Subject: Sabre-arc 25i
Number: 175
Date: 25th September 2000
From: Technical & Marketing Manager - Arc Equipment

SERVICE BULLETIN

Sabre-arc 25i Front Panel Control PCB

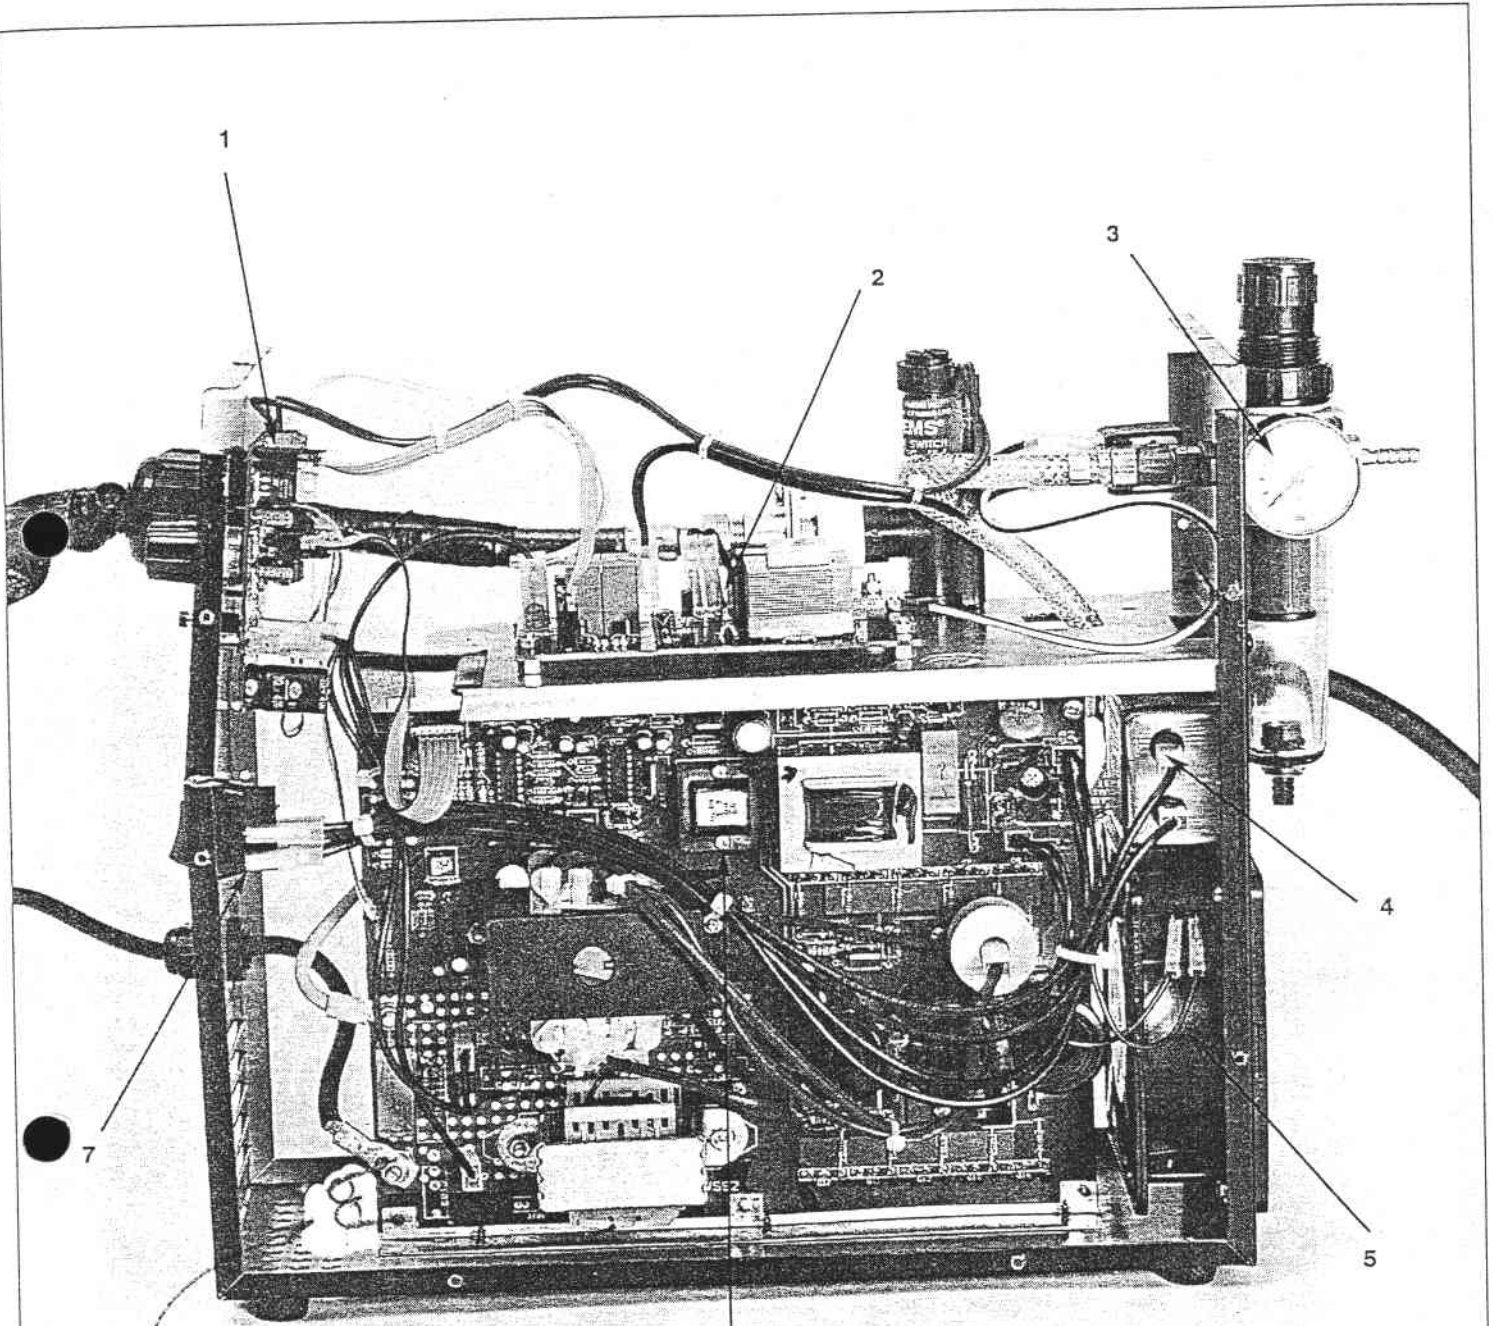
Replace this resistor
with 100 ohm
1/2W Carbon

ADD VARISTOR ASS'Y
 (2 VARISTOR IN SERIES!)
 BETWEEN WORK RETURN LEAD
 CONNECTION & CHASSIS AS SHOWN
